June 10, 2010

RE: Liberty Transmission Proposal

Liberty Transmission Proposal (revised)
502 Junction – Hunterstown (50% series compensation)
Hunterstown – Three Mile Island
Hunterstown - Kemptown
Lexington – Dooms (2nd Circuit)

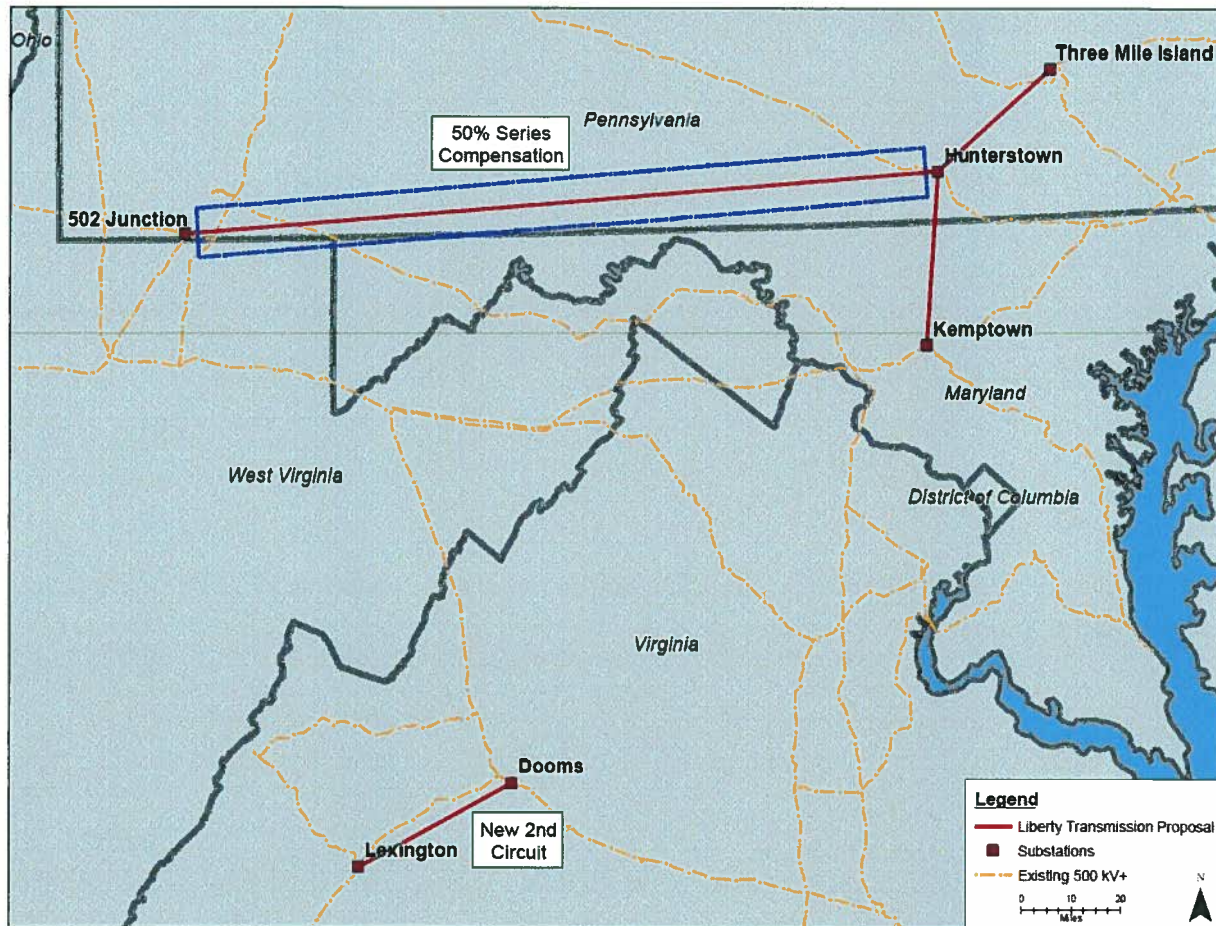
- (1) Removal of the originally proposed Meadow Brooks- Doubs 500kV line;
- (2) Addition of a 2nd 500 kV circuit from Lexington – Dooms;
- (3) Addition of 50% series compensation on the originally proposed 502 Junction – Hunterstown 500 kV line; and

(4) Addition of a new 500 kV line from Hunterstown – Kemptown.

Northeast Transmission has conducted analysis on these enhancements and, based on its analysis, believes that these enhancements will allow the Liberty Transmission Proposal to resolve the thermal issues at a level comparable or exceeding the other alternatives being considered (i.e. for the entire 15-year planning horizon). The map below outlines the entirety of the revised Liberty Transmission Proposal:
